Subject: FW: Alexandria's Comments on Mirant PRGS's SOP
FYI.

**Re: Proposed Stationary Source Permit to Operate Dated October 19, 2007
Mirant Potomac River Generating Station, Alexandria, Virginia**

The City of Alexandria ("Alexandria") appreciates the opportunity to provide comments on the above-referenced State Operating Permit ("SOP") for Mirant's Potomac River Generating Station ("PRGS") located in Alexandria, Virginia. As proposed, the SOP contains several crucial deficiencies that must be addressed prior to the issuance of a final permit. This letter discusses each of those deficiencies, and urges the State Air Pollution Control Board ("Board") and Virginia Department of Environmental Quality ("VDEQ") to resolve them in the final SOP. In addition, the letter addresses the seven questions for which the Board requested public comment.

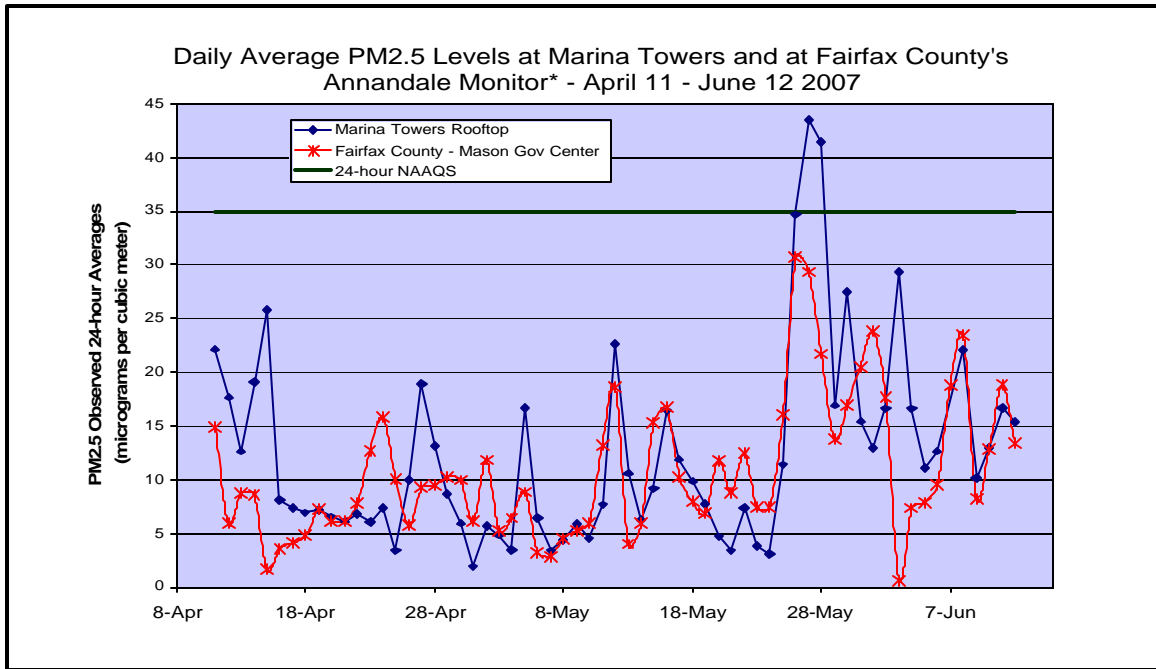
Alexandria believes that installation of baghouses, possibly combined with some operational restrictions at PRGS, will reduce PM_{2.5} emissions to a level necessary for NAAQS compliance. In the absence of baghouses, substantial curtailment of operations is required. Therefore, it is evident that Conditions 23 through 28 of the proposed SOP must be modified to reflect the required PM_{2.5} emission limitations for all boilers.

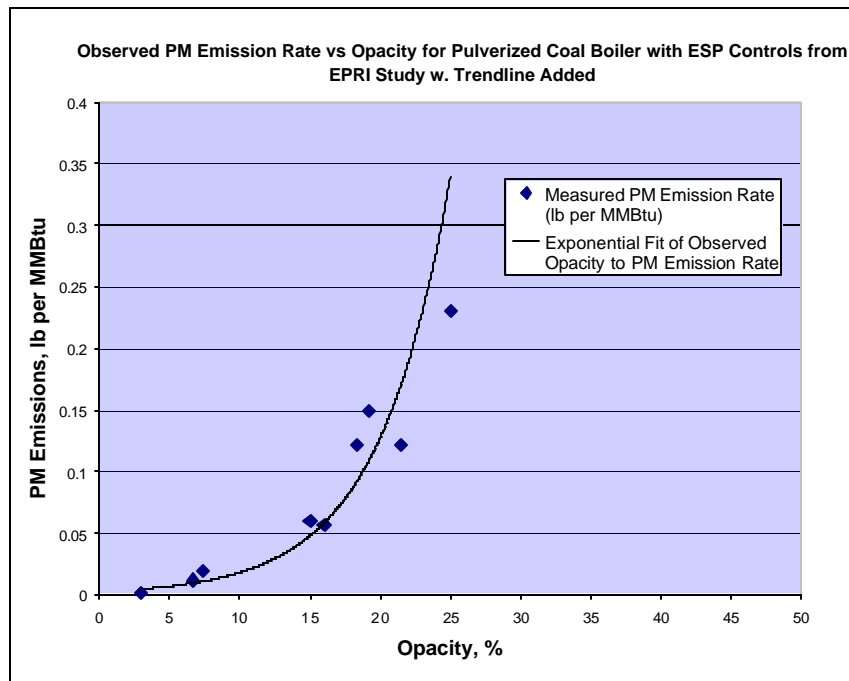
The figure below shows a curve fit between observed emission rates and opacity for testing of a pulverized coal boiler, obtained by Electric Power Research Interest Group, and reported by U.S. EPA.⁷ These data clearly show that opacity positively correlates with PM emissions. Of particular concern to Alexandria is the fact that opacity is closely related to fine particulate matter in the size range of about 1 µm. Therefore, any increase in opacity is very likely related to increases in PM_{2.5} emissions.

In response to Alexandria’s recent request for data and analyses relating opacity increases to either increases or decreases in PM emissions, VDEQ wrote that it has “*determined that the information that you have requested cannot be found or does not exist in the records of the Department of Environmental Quality*” and that the VDEQ is “*not aware of another source of the information you requested.*” VDEQ also wrote that the “*Department is neither aware of nor in possession of the any documents, studies, or analyses relating the two or discussing the effect of increased opacity on emissions of total PM.*” Yet, VDEQ appears to agree with Mirant’s claim that the December 2006 stack test demonstrated a reduction in PM emissions due to the use of trona. On the contrary, the December 2006 stack test is inadequate to make such a claim. First, the comparison of PM emissions with and without trona was only performed for one boiler that showed the smallest increase in opacity, i.e., Boiler 3. No other boiler was tested for this purpose. Second, the stack test reflects a one-time demonstration under controlled circumstances that are not representative of routine emissions. This is evidenced by the fact that Mirant has requested a PM emission limit of 0.055 lb/MMBtu, i.e., a limit that is two to five times higher than the actual stack test results. Additionally, and perhaps most importantly, the stack test results without trona use are based on a dismal performance of the cold-side ESP (CSEP3), i.e., an average PM control efficiency of only 53%. Such low control efficiency represents faulty performance of CSEP3 and resulted in higher PM emissions during the tests when trona was not in use. In contrast, the CSEP3 control efficiencies during the tests with trona ranged from 89% to 94%, which are more representative of the actual capability of CSEP3. Therefore, while the stack test with trona may reflect accurate emissions from Boiler 3, a comparison of these emissions with the results without trona is flawed and cannot be used to claim PM reduction due to trona use. Alexandria requests the Board and VDEQ to remove the reference to dry sorbent injection as a means to control PM emissions in Condition 5 of the proposed SOP.
